2825 Coon Rapids Blvd

NORTH STAR ENGINEERING CONSULTANTS, INC.
12610 - 58th Avenue North : Plymouth, Minnesota 55442 (612) 559-3642

SS 5312 RK 16668
AMOCO OIL COMPANY
Co. Rd. 10 & Crooked Lk. Rd.
COON RAPIDS, MN.

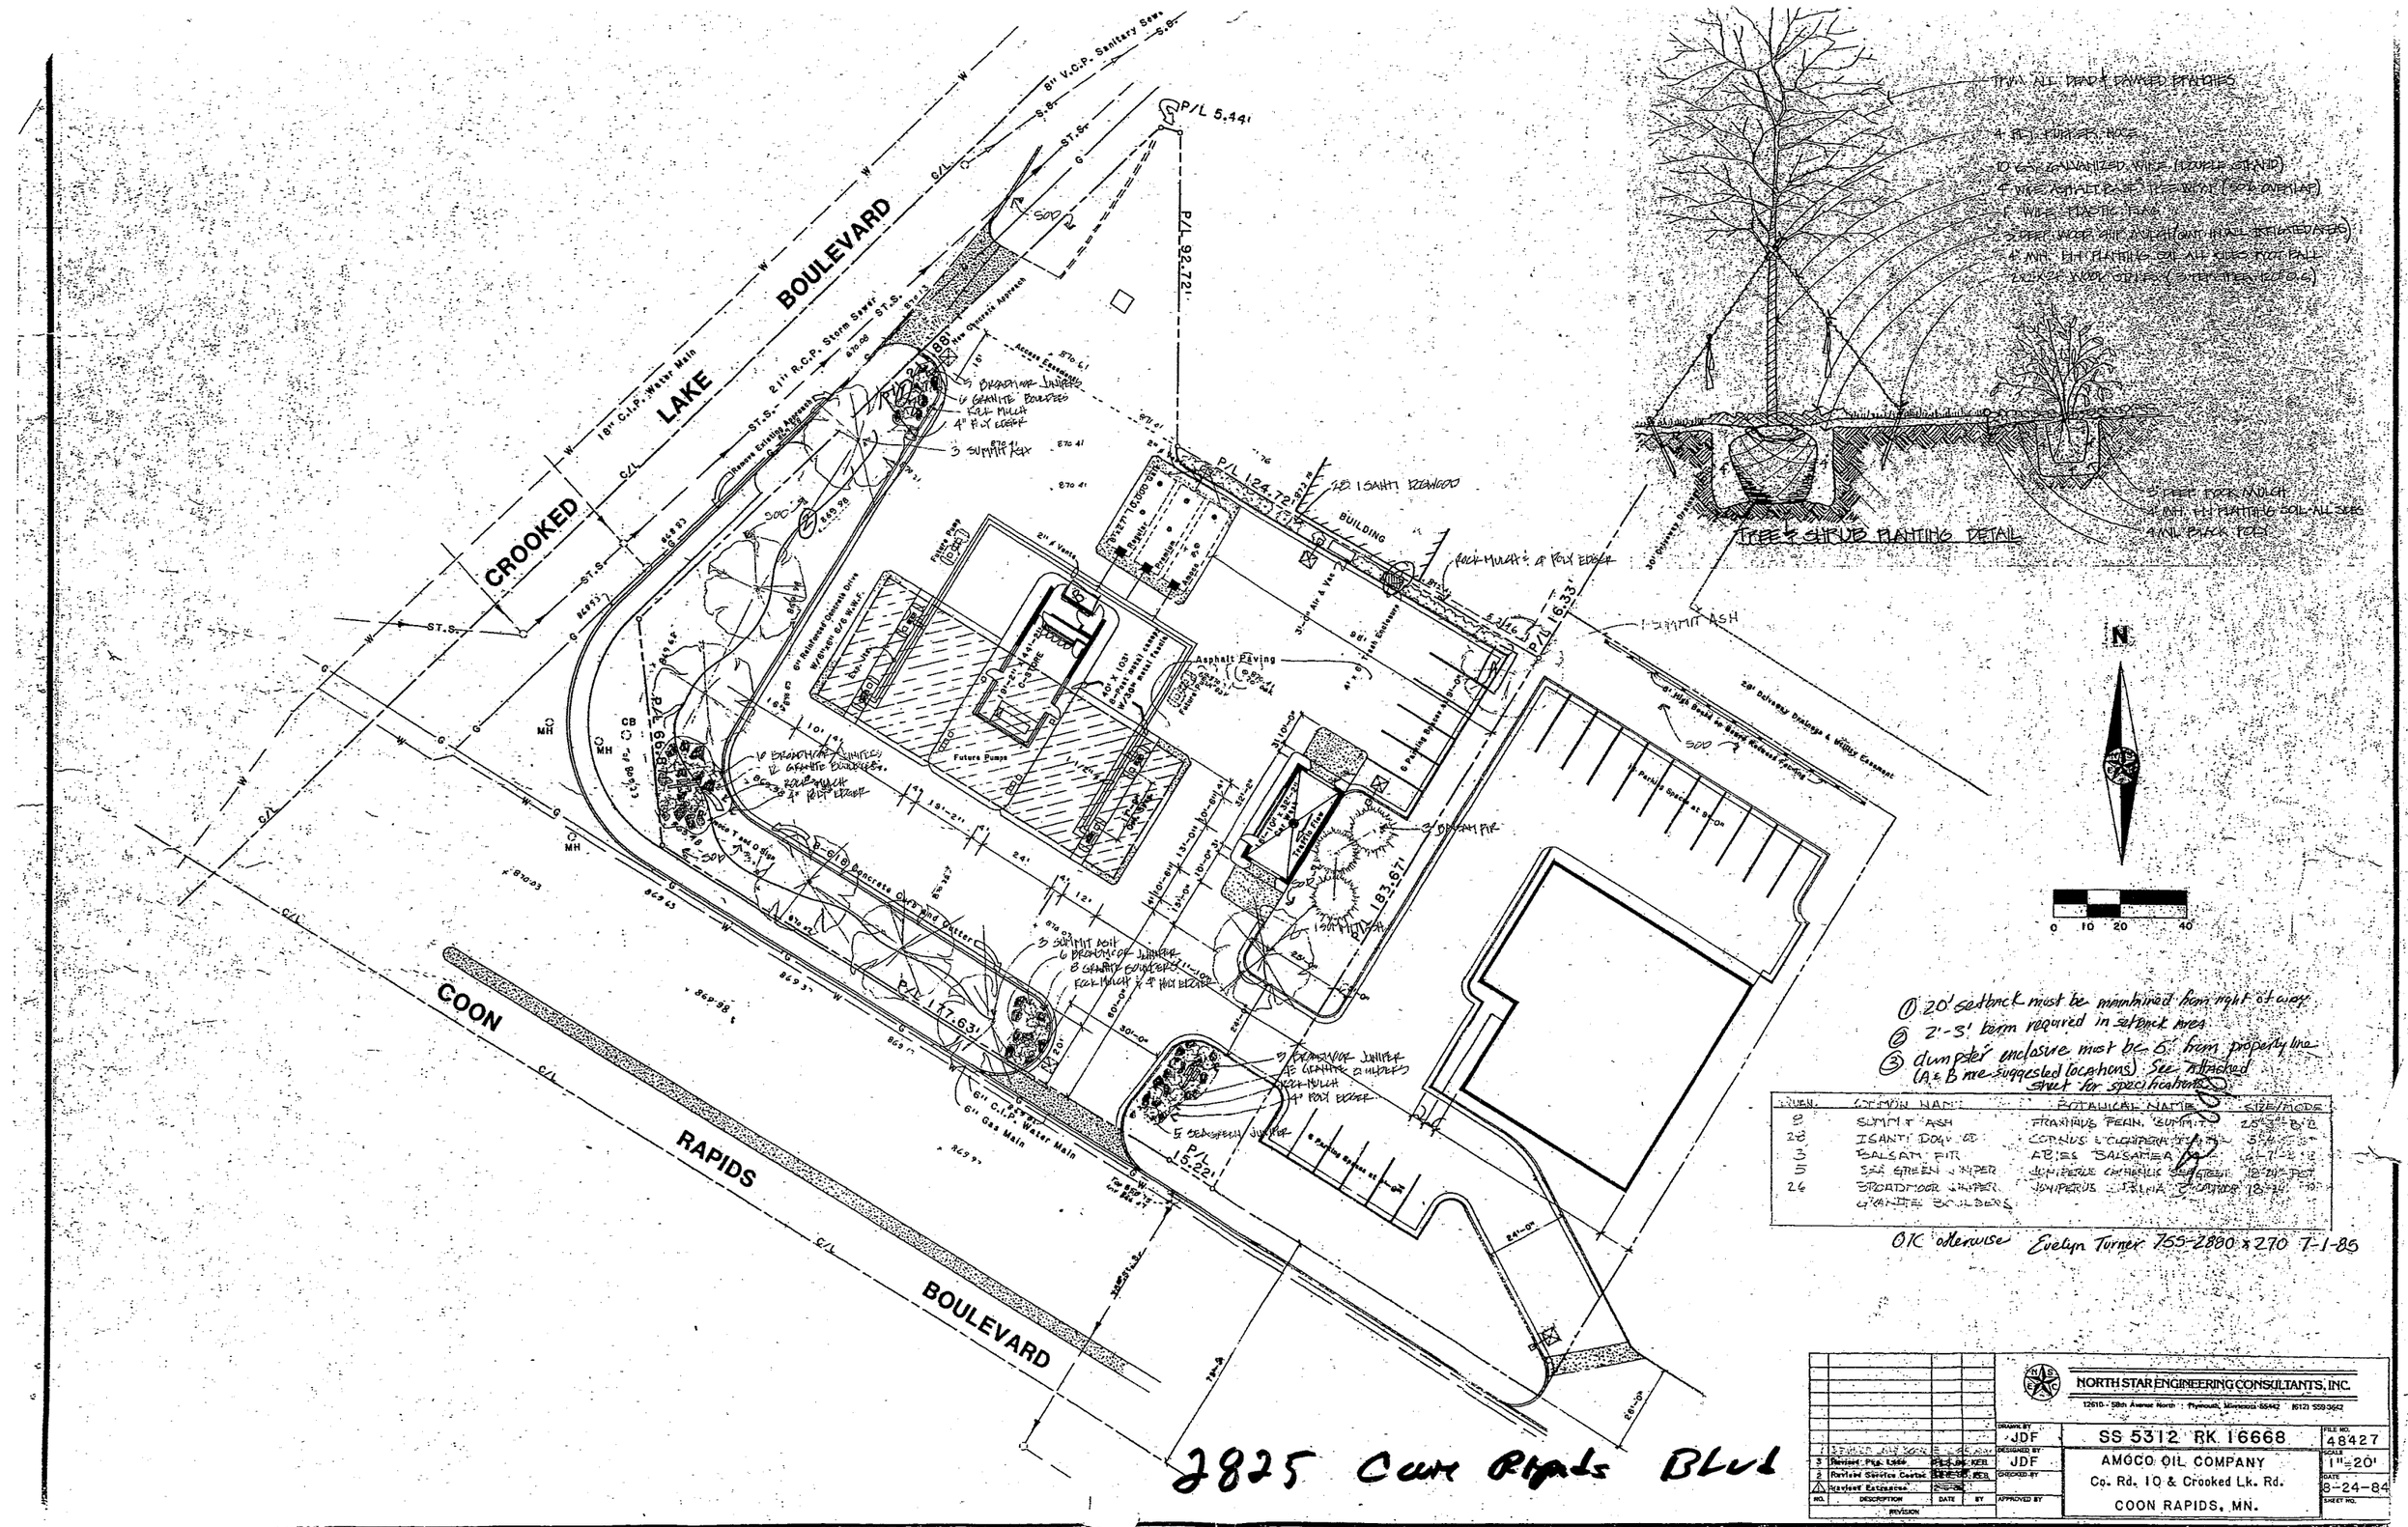
① 20' setback must be maintained from right of way
② 2'-3' berm required in setback area
③ dumpster enclosure must be 6' from property line (A & B are suggested locations) See attached sheet for specifications

OK otherwise Evelyn Turner 755-2880 x 270 7-1-85
